**PLANNING APPROVAL,
PLANNED UNIT DEVELOPMENT &
SUBDIVISION STAFF REPORT****Date: October 16, 2014**

<u>NAME</u>	McGill-Toolen High School
<u>SUBDIVISION NAME</u>	McGill-Toolen High School Subdivision, Phase Three
<u>LOCATION</u>	1501 Old Shell Road, 1557 Spring Hill Avenue and 8 & 12 North Lafayette Street. (Areas bounded by Old Shell Road, North Catherine Street, Spring Hill Avenue and North Lafayette Street)
<u>CITY COUNCIL DISTRICT</u>	District 2
<u>PRESENT ZONING</u>	B-1, Buffer Business District, R-1, Single-Family Residential District, and R-3, Multi-Family Residential District.
<u>AREA OF PROPERTY</u>	3 Lots / 3.4± Acres
<u>CONTEMPLATED USE</u>	Planning Approval to amend a previously approved Planning Approval to allow a parking lot expansion for a private church school in an R-1, Single-Family Residential District; Planned Unit Development approval to amend a previously approved Master Plan to allow a new parking lot, expansion of an existing parking lot, and shared access and parking; and Subdivision approval to create three legal lots of record.

SITE PLAN

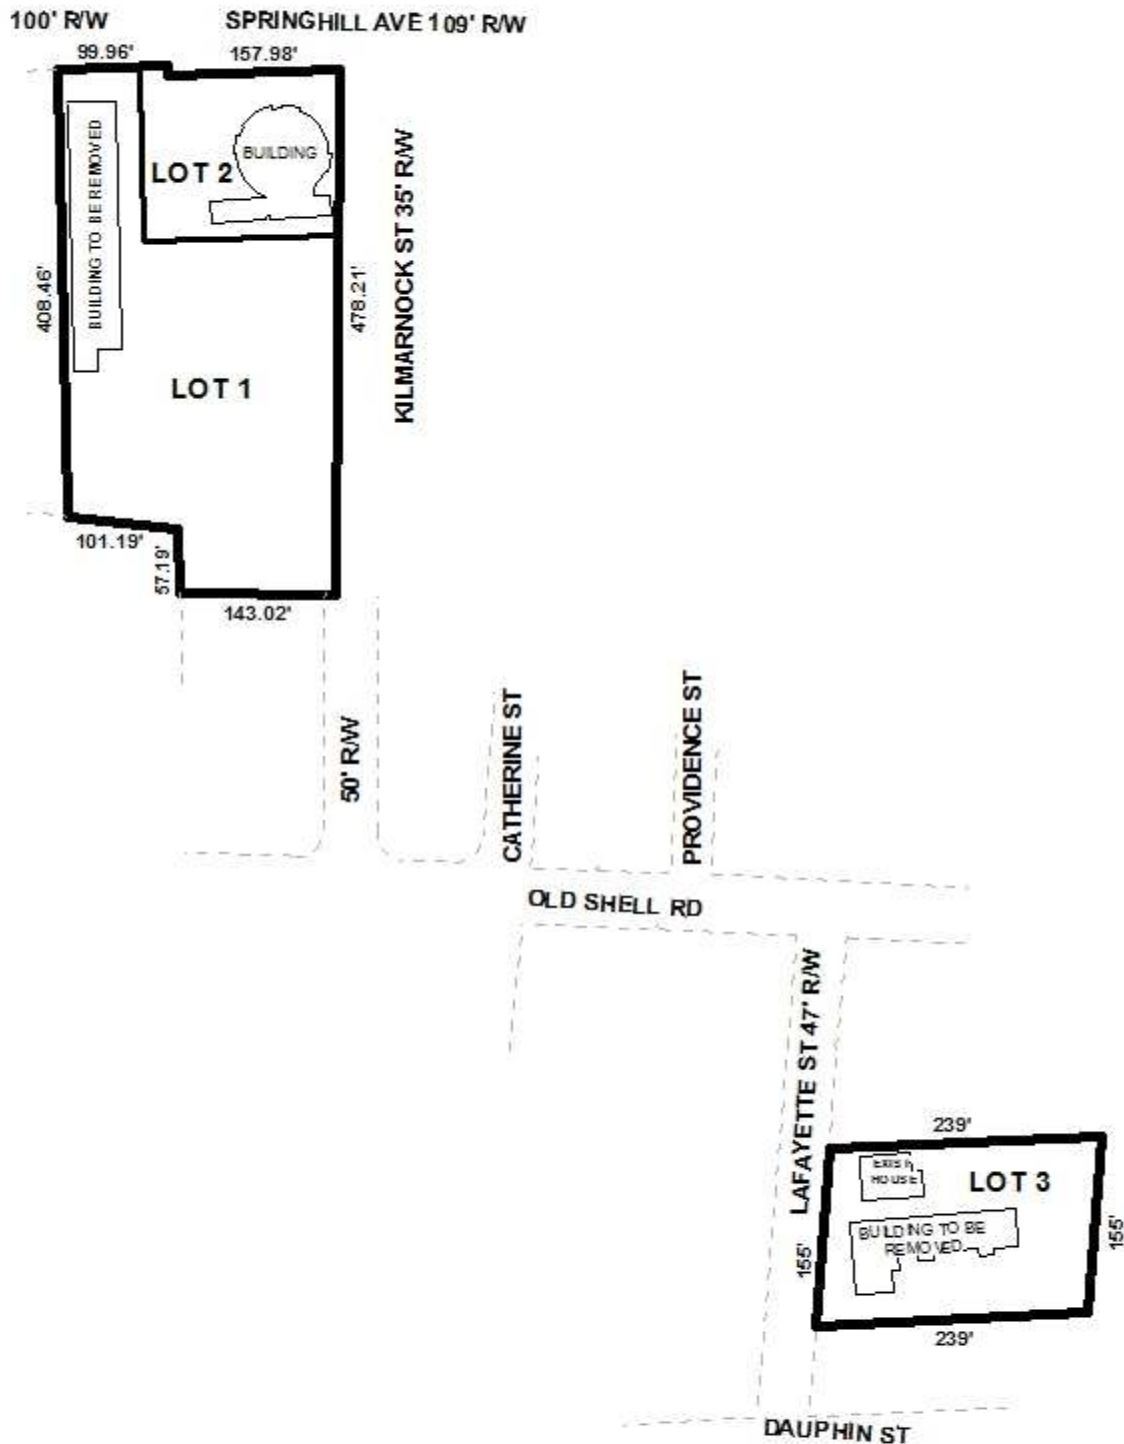
With regard to the Planning Approval and PUD site plans, there are no calculations given for the required number of parking spaces based upon the student count and no number given for the total existing spaces. High schools require one parking space for every four students. The applicant's web site profile for 2013-2014 indicates approximately 1180 students enrolled in grades nine through twelve which would require approximately 295 parking spaces. Staff's count of existing parking spaces shown on the site plans indicates approximately 394 spaces. There are 283 new parking spaces stated as proposed. This would give a total of approximately 677 parking spaces. The exact number of existing parking spaces shown is hard to determine because the configuration of the spaces along the South and East sides of the large grass field on the North side of the main campus is different from what is indicated on aerial photographs. And the exact number of proposed parking spaces given (283) is different from what is indicated graphically by count on the site plans (278). There are 66 new spaces stated and 61 graphically-indicated within the proposed Lafayette Street expansion. None of the existing parking directly North of the field house is indicated, and the site plan indicates an existing building in that area which actually does not exist. And none of the existing nose-in/back-out parking along the West side of North Lafayette Street is indicated. The site plans should be revised to give the actual enrollment and calculated required parking spaces, the actual configuration and number of all existing parking spaces and buildings, and the actual number and configuration of proposed parking spaces. The numbers for the total parking spaces proposed after the parking expansions should be after any required revisions to the site plans.

It should be noted that there is no scale indicated on the site plans, and no scale could be graphically-determined. Therefore, revised site plans should be drawn to a given scale. Pertaining to revised site plans, both North Lafayette Street and Kilmarnock Street are of substandard right-of-way along the subject sites. As dedications will be required via the Subdivision, the site plans should be revised accordingly. And as full compliance with the buffering, tree planting and landscaping requirements of the Zoning Ordinance will be required, the site plans should be revised to indicate such, to include a 6' high wooden privacy fence along adjacent residential sites, frontage and perimeter trees and parking trees.

- 6) revision of the site plan to accurately depict the existing building configurations;
- 7) revision of the site plan to eliminate one of the three student parking lot curb cuts along North Lafayette Street, either by sharing access between the existing and proposed parking areas utilizing the two existing curb cuts, or eliminating one of the existing two curb cuts on the existing parking area;

- 9) revision of the site plan to indicate exit onto Spring Hill Avenue for the Northwest parking area as being right-out only and not to have any entry from Spring Hill Avenue, with the specific design of the curb cut to be coordinated with the Fire Department for access requirements, ALDOT, and Traffic Engineering;

- 6) revision of the site plan to accurately depict the existing building configurations;
- 7) revision of the site plan to eliminate one of the three student parking lot curb cuts along North Lafayette Street, either by sharing access between the existing and proposed parking areas utilizing the two existing curb cuts, or eliminating one of the existing two curb cuts on the existing parking area;

- 9) revision of the site plan to indicate exit onto Spring Hill Avenue for the Northwest parking area as being right-out only and not to have any entry from Spring Hill Avenue, with the specific design of the curb cut to be coordinated with the Fire Department for access requirements, ALDOT, and Traffic Engineering;
